AMENDMENTS TO THE DRAWINGS

REMARKS

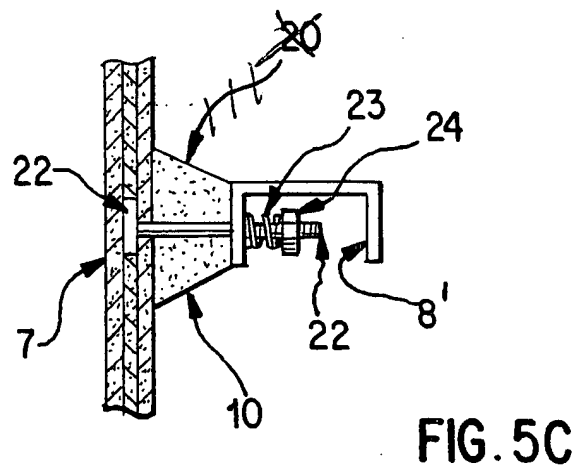
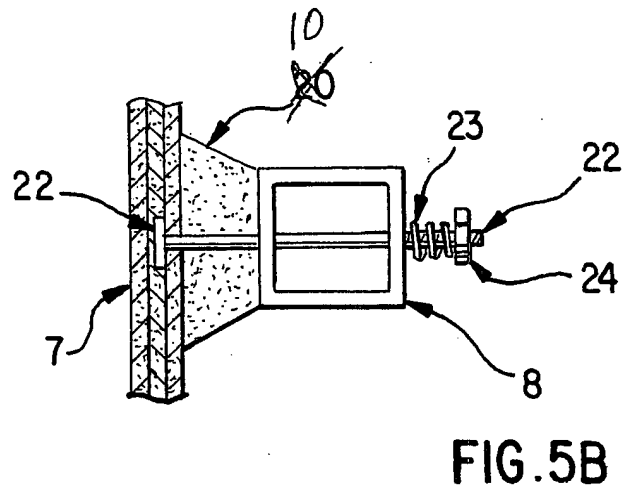
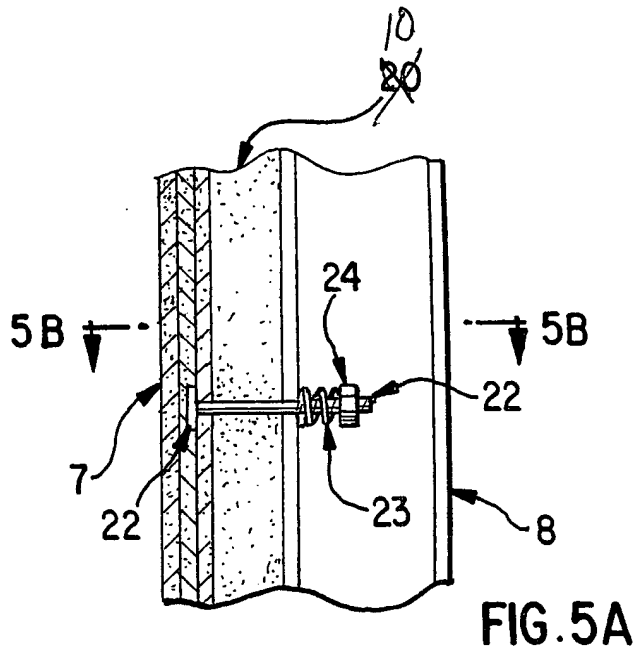
Additionally, the same parts had been designated in the specification by different reference numerals. More specifically, the elastomer has been identified, for example, in Figure 5C by reference numeral (10) as also by reference numeral (20). To assure uniformity, Figures 5A, 5B and 5C are amended to provide consistency. Approval of these changes is respectfully requested as no new matter is involved, and it is further requested that the Replacement Sheets be made a part of the record of the above-identified application.

FIG. 6B

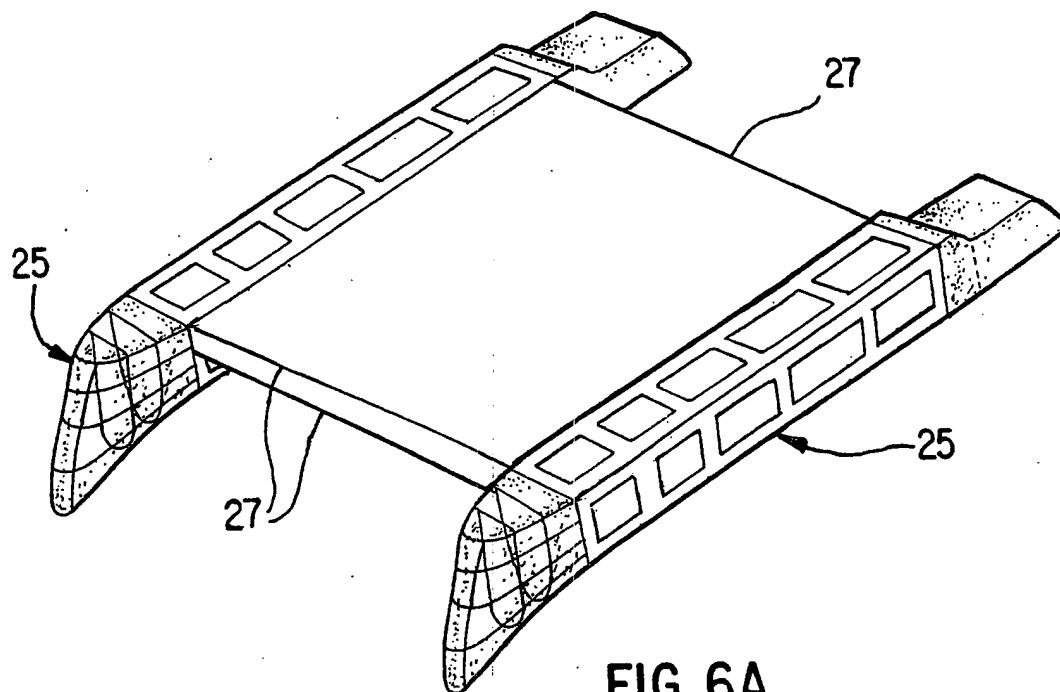
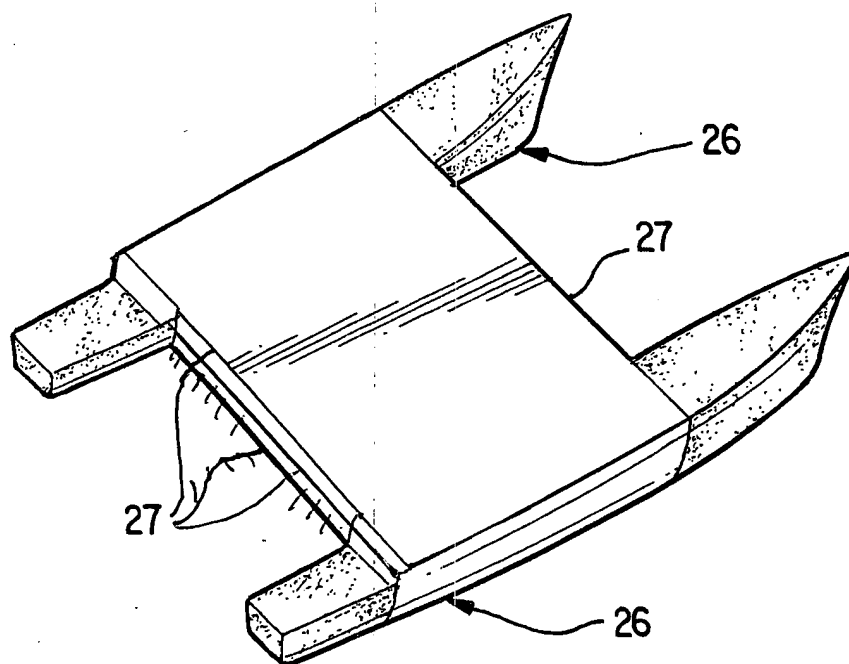
Finally, Figure 6B is also changed to provide uniformity between Figures 6A and 6B of the thickness of the connection cross structure which is made of stiffened steel plating as used in conventional ship design (see page 11, lines 1-12 of the original disclosure). There is no difference between these two figures insofar as this part is concerned.
